COOPER RIVER REDIVERSION PROJECT LAKE MOULTRIE AND
SANTEE RIVER SOUTH CAROLINA FISH HATCHERY(U) CORPS OF
ENGINEERS CHARLESTON SC CHARLESTON DISTRICT JUL 80

DESIGN MEMORANDUM NO. 14

SADEN-GP (11 Sep 80) 3rd Ind
SUBJECT: Cooper River Rediversion Project, Design Memorandum 14 -
Fish Hatchery

SADEN-GP (13 Feb 81) 1st Ind
SUBJECT: Cooper River Rediversion Project, Design Memorandum 14 - Fish
Hatchery

BY TCY DATE 2 80 SUBJECT C.O.E. - S.C. SHEET NO. 1 OF 1
 CHECKED BY DATE FISH HATCHERY NO 70116-10
 LAYOUT PLAN - A.I.T. NO. 1

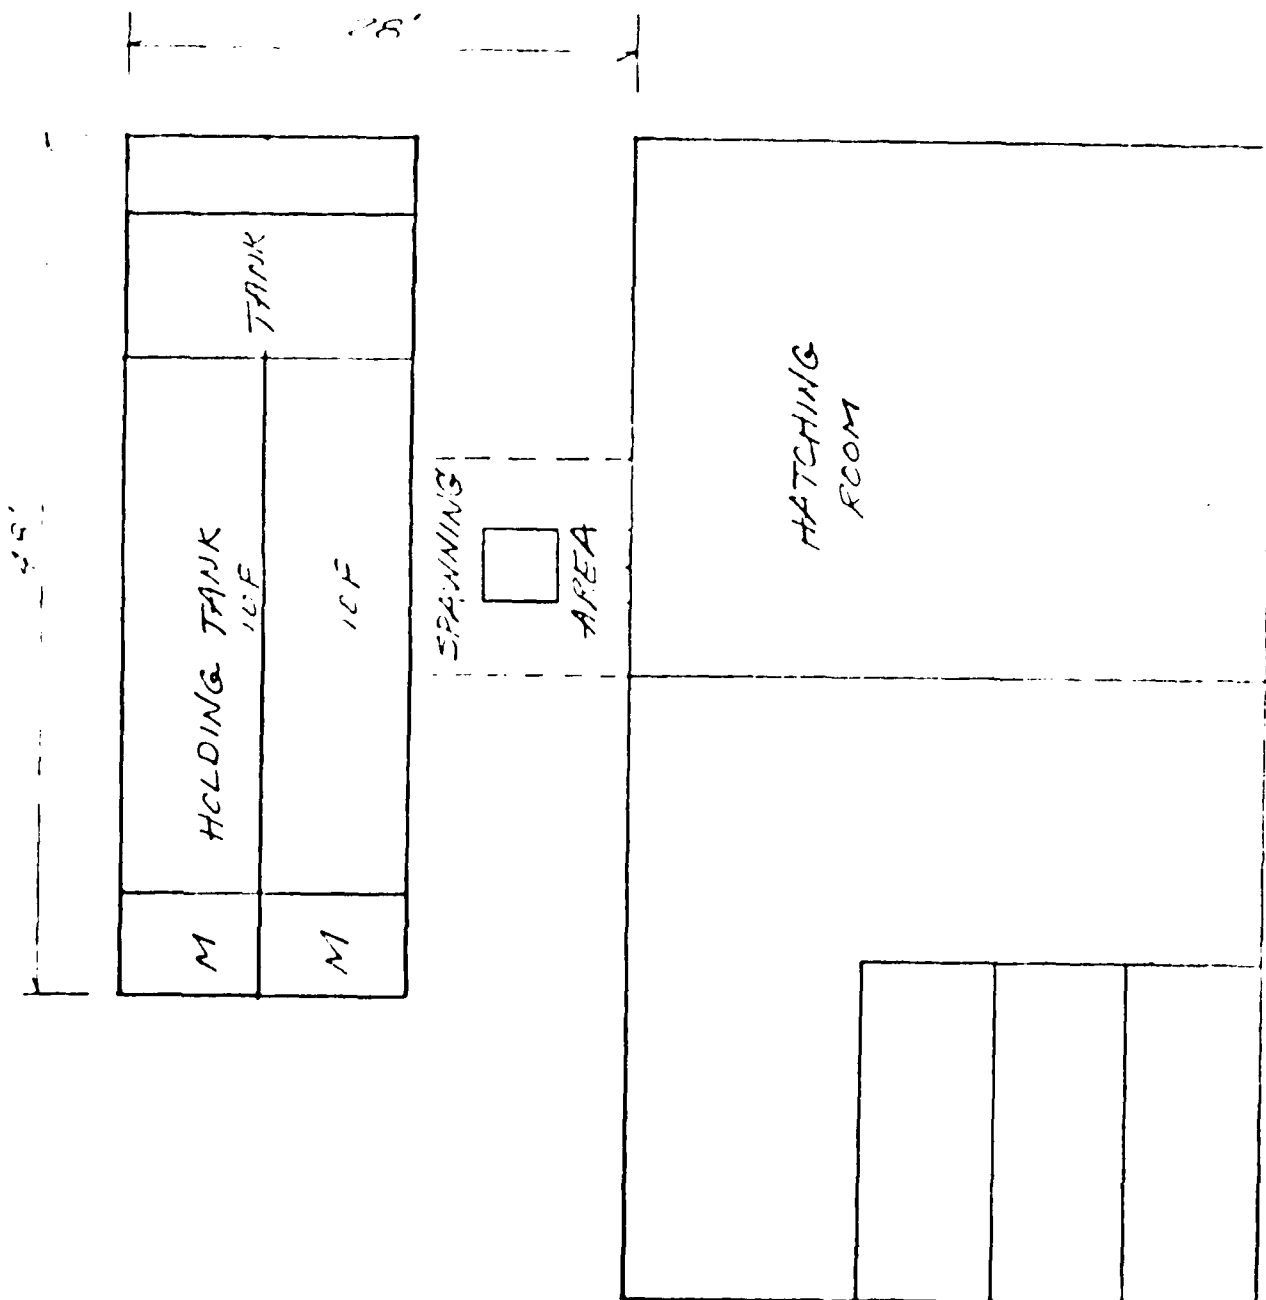
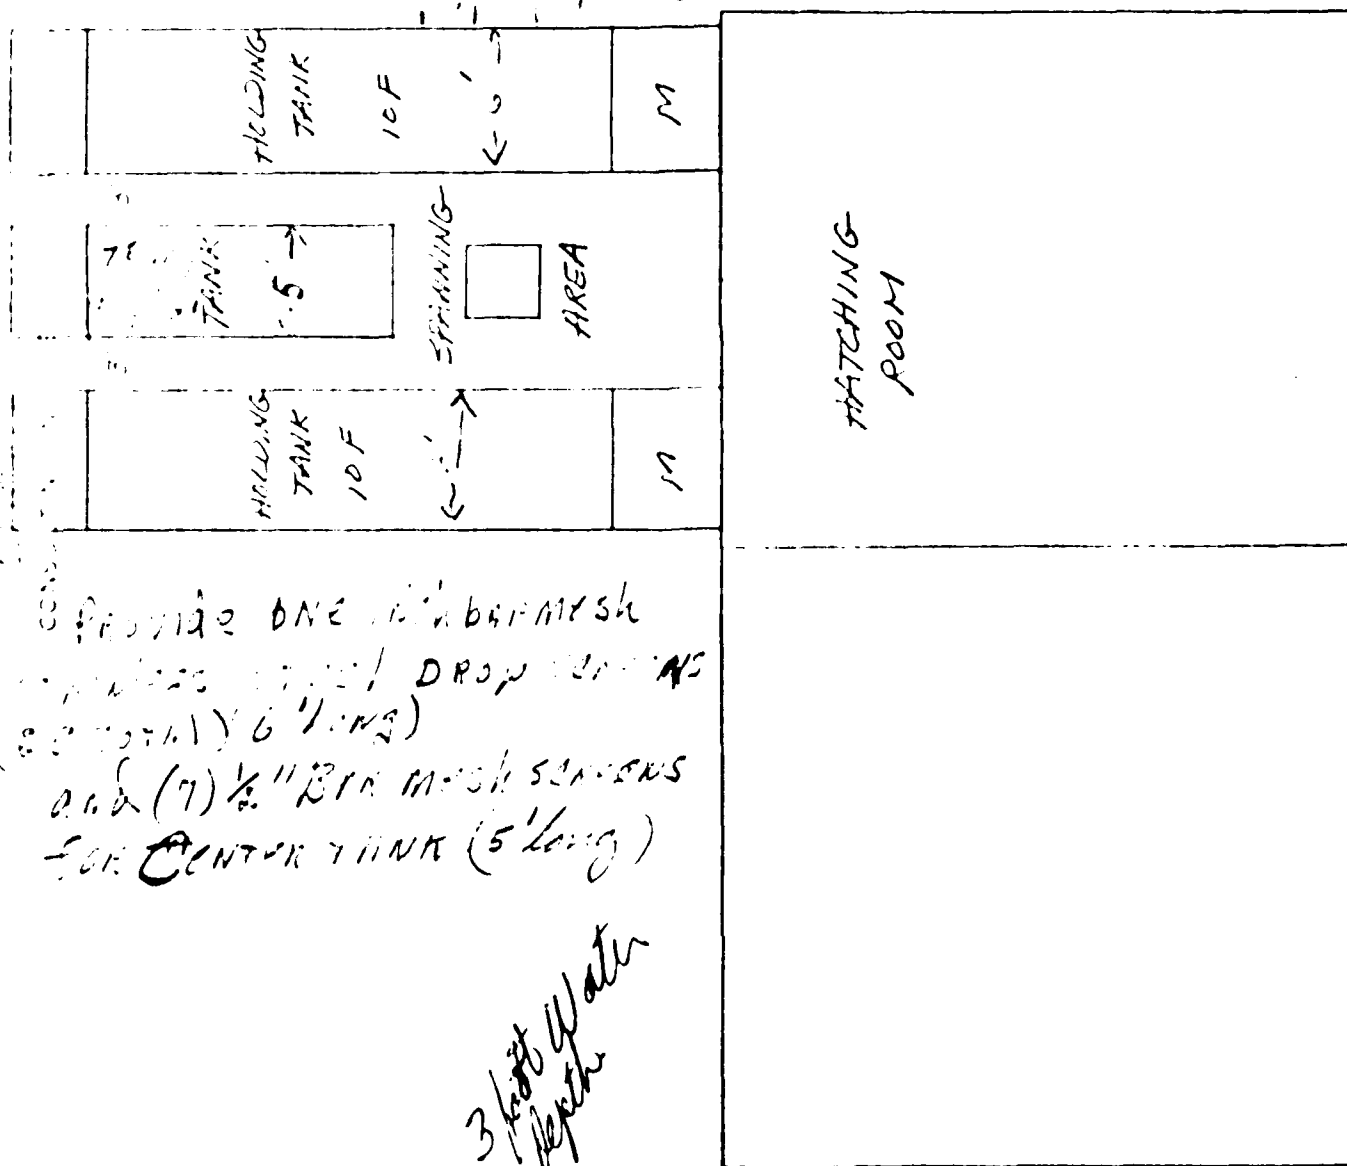
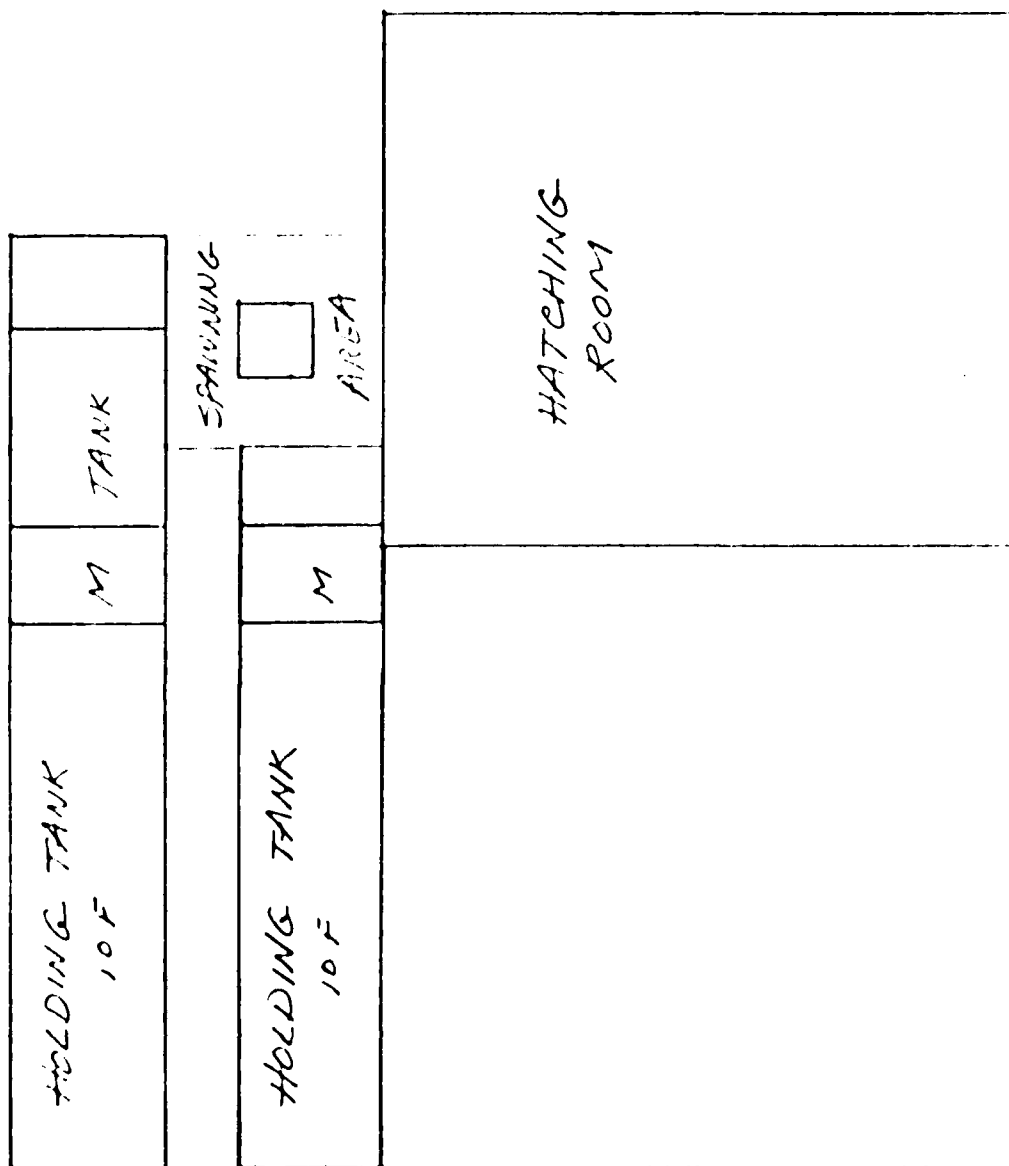
Attached please find copies of your suggested layout plan.
We prefer alternate number 2 and have made some suggestions
on the drawing which we feel will help the overall setup.
